RE: AMENDING SITE PLAN (SP2018-018), Site Plan for 125 National Drive

Project Number SP2018-018	Owner RACK, PARTNERS LTD	Applied 6/15/2018 DG
Project Name Site Plan for 125 National Drive	Applicant David Osborn	Approved
Type SITE PLAN		Closed
Subtype AMENDING		Expired
Status NEED REVISIONS		Status 6/19/2018 RM

AGENDA ITEM: **SP2018-018;** *125 National Drive*

125 NATIONAL DR.

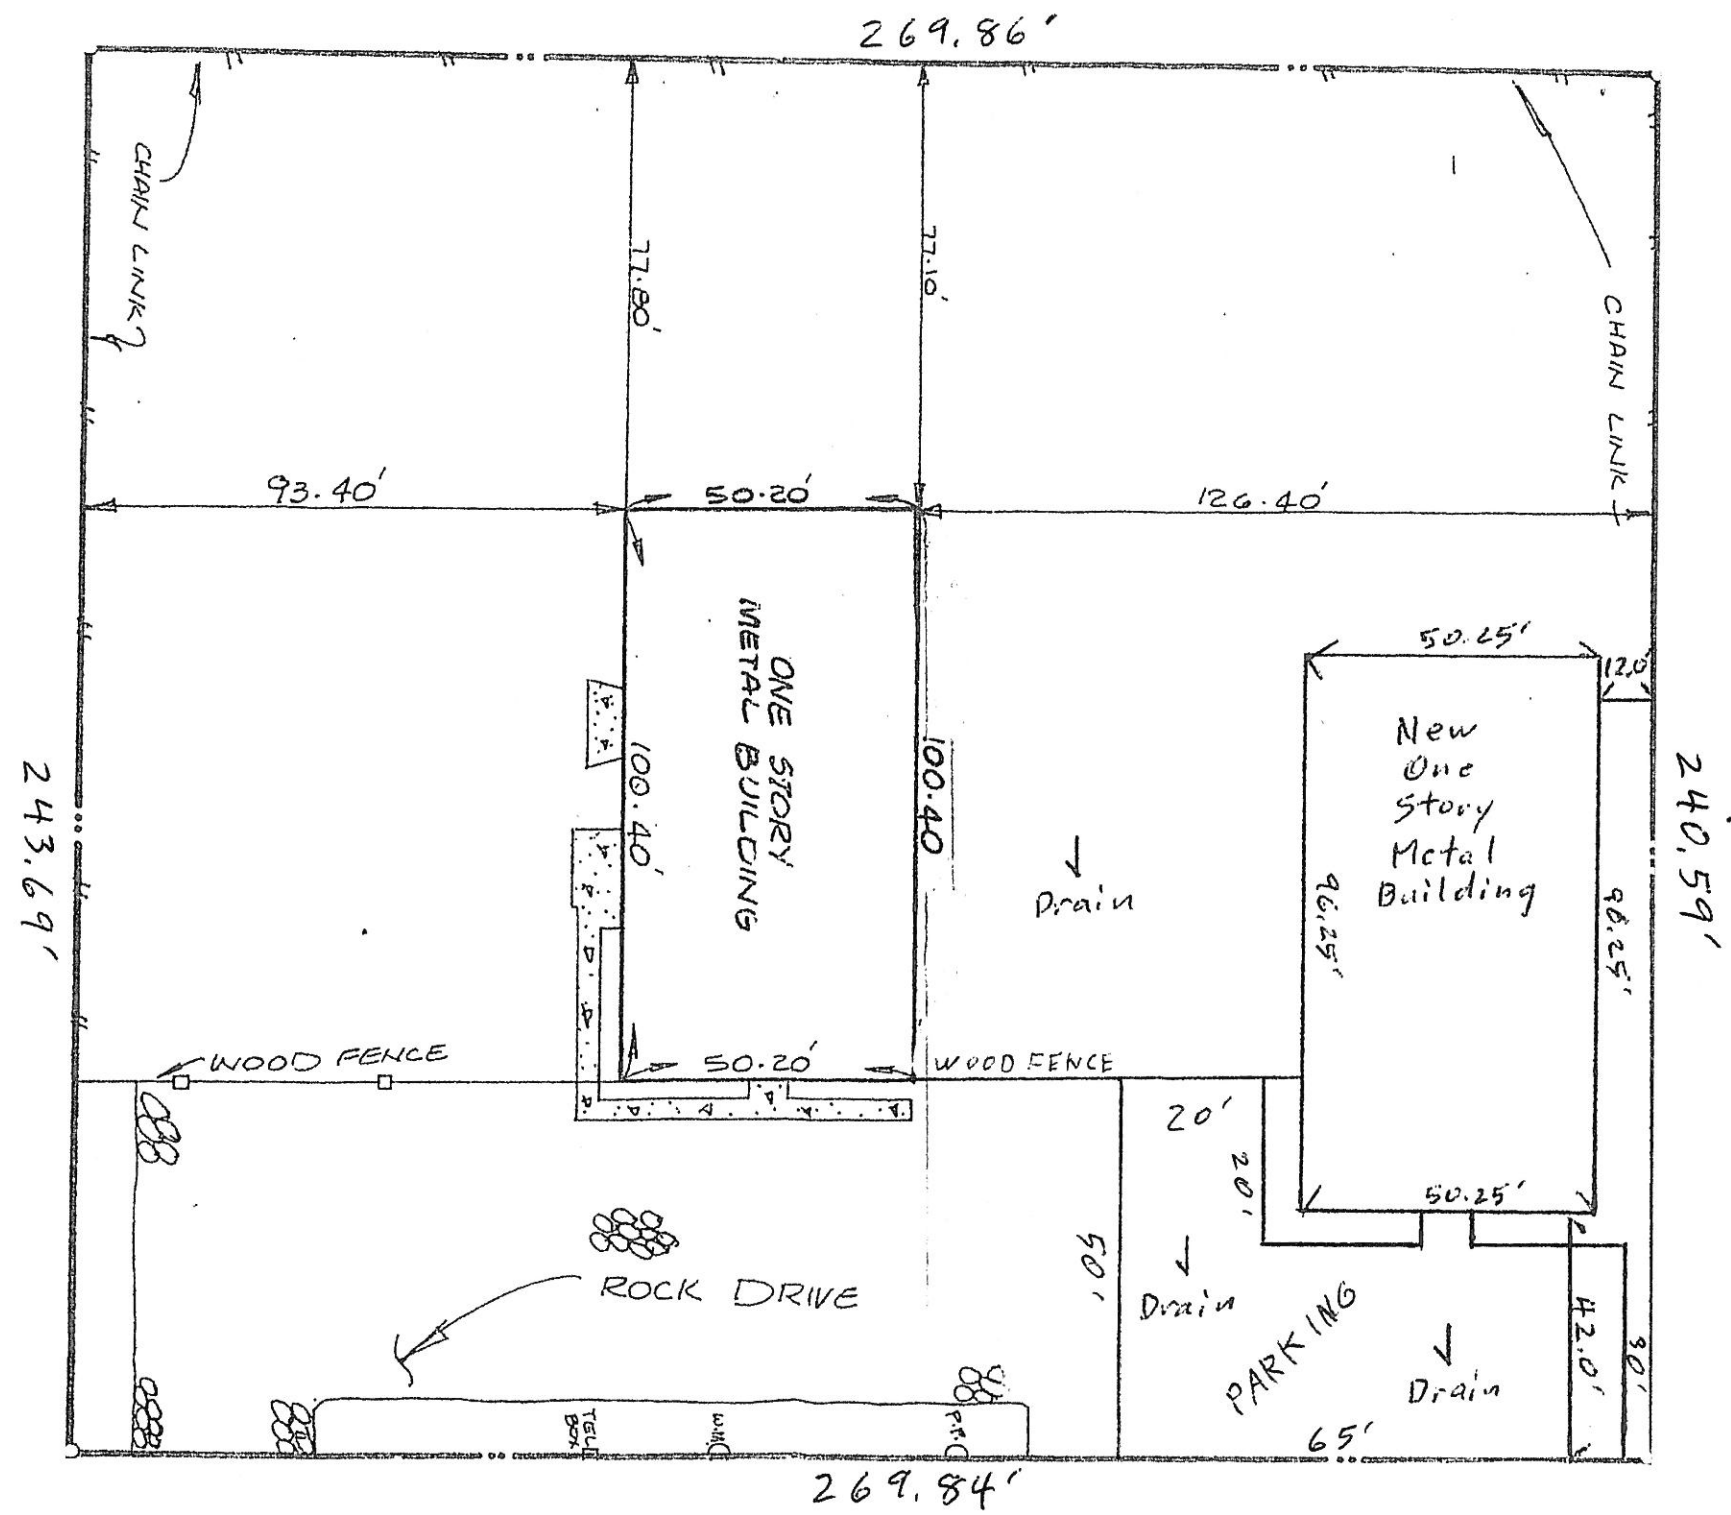
Type of Review / Notes	Contact	Sent	Due	Received	Elapsed	Status	Remarks
Building Inspections Di	Russell McDowell	6/19/2018	6/21/2018	6/21/2018	2	APPROVED	
Engineering Departme (6/20/2018 10:52 AM AW) See Markup - Detention is required - 4% Engineering Inspection Fees - Impact Fees - Need to show existing and proposed utilities on site plan - Detention is required and needs to be shown in the approximate location - Need to show parking striping, any fire lane (if required), and driveway with culverts if needed - Can't have a continuous connection of paving to National. Need driveway with 24' drive aisles in property - Need letter from the County stating that the existing septic system will have the capacity for the expansion	Amy Williams	6/19/2018	6/21/2018	6/20/2018	1	COMMENTS	See Comments
Fire Department	Ariana Hargrove	6/19/2018		6/21/2018	2	COMMENTS	see comments

Type of Review / Notes	Contact	Sent	Due	Received	Elapsed Status	Remarks
SP2018-018; Site Plan for 125 National Drive						
Please address the following comments (M= Mandatory Comments; I = Informational Comments)						
I.1 This is a request for the approval of a site plan for an industrial building on a 1.50-acre tract of land identified as Tract 2-16 of the J. R. Johnson Survey, Abstract No. 128, City of Rockwall, Rockwall County, Texas, zoned Heavy Commercial (HC) District, and addressed as 125 National Drive.						
I.2 For questions or comments concerning this case please contact Ryan Miller in the Planning Department at (972) 772-6441 or email rcmiller@rockwall.com.						
M.3 For reference, include the case number (SP2018-018) in the lower right hand corner of all pages on future submittals.						
I.4 Site Plan. According to Section 2.3, Expansion of an Existing Use, of Article VI, Parking and Loading Standards, of the Unified development Code (UDC), "(i)f any building, improvement, or use of land is expanded, the provisions for parking and loading shall be provided for the portion of land use and/or building that has been added."

M.5 Site Plan. Please indicate that the additional parking will be concrete and show line stripping for five (5) additional parking spaces.						
M.6 Landscape Plan. Per the requirements of the landscaping ordinance please provide one (1), three (3) inch caliper tree per 100-linear feet of street frontage. A total of three (3) trees will be required. Please indicate this on the site plan.						
M.7 Building Elevations. Please provide a picture of the existing metal building on the site.						
M.8 Building Elevations. The proposed building elevations do not meet the minimum masonry requirements. This will require an exception from the City Council.						
M.9 Building Elevations. The proposed building elevations do not meet the minimum horizontal and vertical articulation requirements. This will require a variance from the City Council.						
I.10 The Architectural Review Board (ARB) meeting for this case will be held on June 26, 2018.

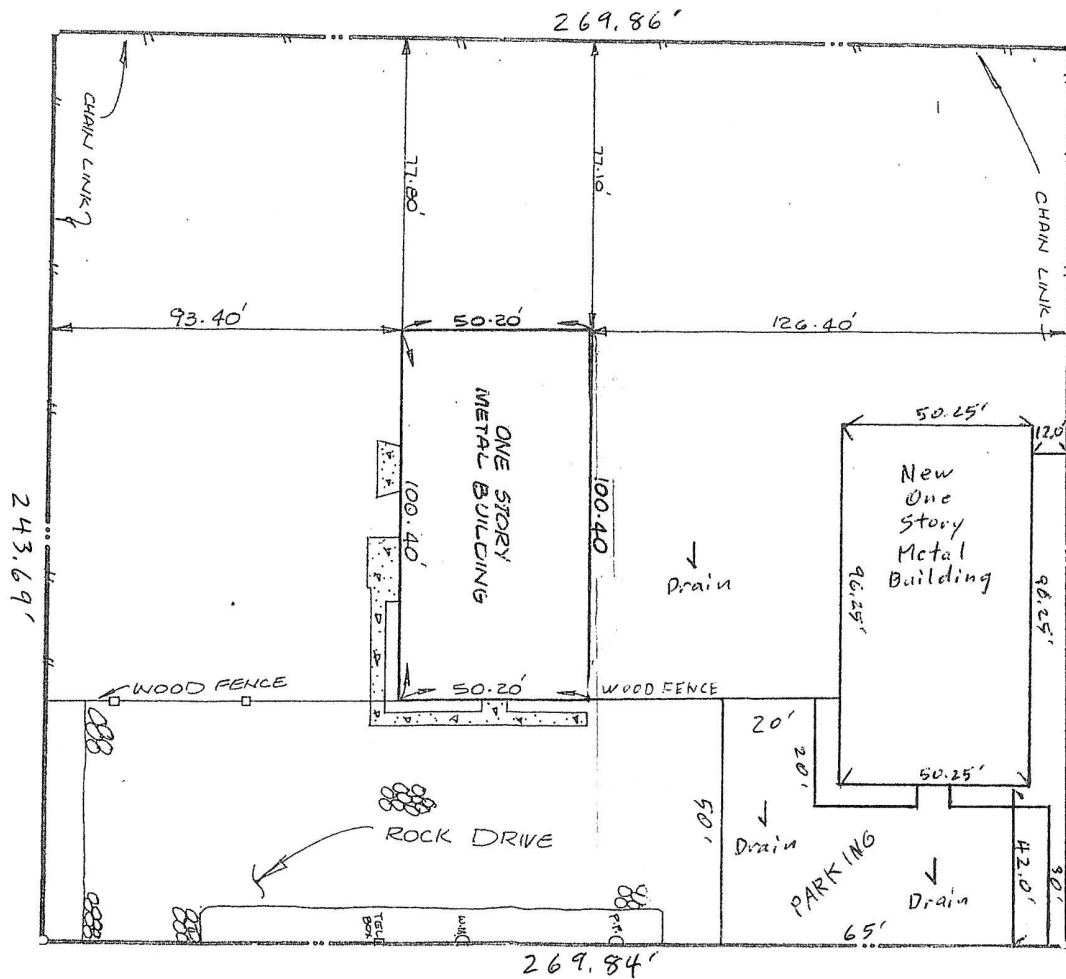
- Detention is required
- 4% Engineering Inspection Fees
- Impact Fees
- Need to show existing and proposed utilities on site plan
- Detention is required and needs to be shown in the approximate location
- Need to show parking striping, any fire lane, and driveway with culverts if needed
- Can't have a continuous connection of paving to National. Need driveway with 24' drive aisles in property
- Need letter from the County stating that the existing septic system will have the capacity for the expansion
